Subject: Chamber Construction Manual
Posted by [Clemens Adler](#) on Thu, 25 Mar 2004 08:24:30 GMT
[View Forum Message](#) <> [Reply to Message](#)

I updated the chamber construction manual (to version 1.1).

1) [image001.gif](#), downloaded 1656 times

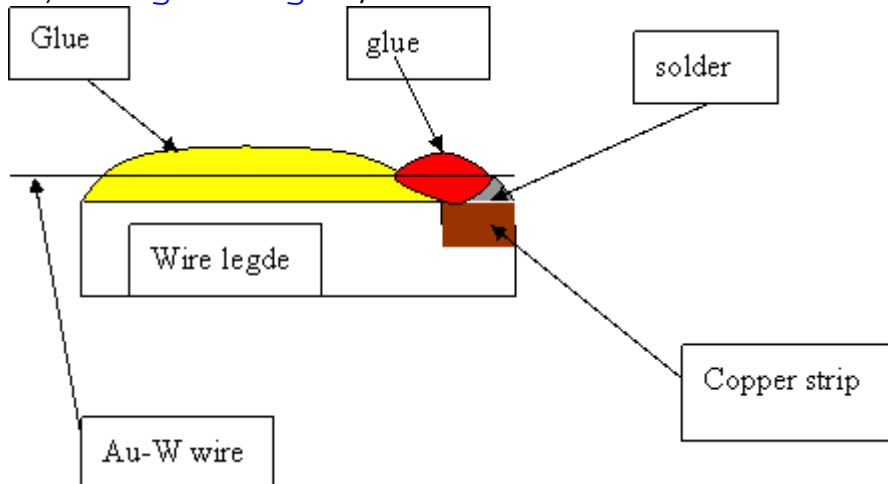
2. An suggestion: Oleg suggests to put some glue to between the glue which holds the anode wire on the wire ledge and the copper strip where the wire is soldered (see attached picture by Oleg).

"after soldering of anode wires we put glue (red color) to fix the wire, solder and copper

strip together. It is need to remember that we have to safe a clean place on the copper strip to solder HV cable."

We also had this idea and did it on some chambers, but after discussion with Joerg at GSI, who never had any similar problem we thought that probably sanding the wire ledge edges is good enough and will solve the problem.

Another problem was that we wanted the glue to be cured before we cut the wires, and then we loose 1 day. This is probably not so critical, since at least in Heidelberg and Dubna where not too many people are involved in cahmber building one can find something else to do during this day.

So I would like to hear from GSI (Joerg) and Bukarest (Mihai) what they think. Since we have not put anodes on a chamber since a while due to technical difficulties with machiniery in our lab, I cannot tell at this moment what our experiences with sanding the wire ledges are. I will, therefore, not add this into the construction manual, until there are some more opinions about this additional step.
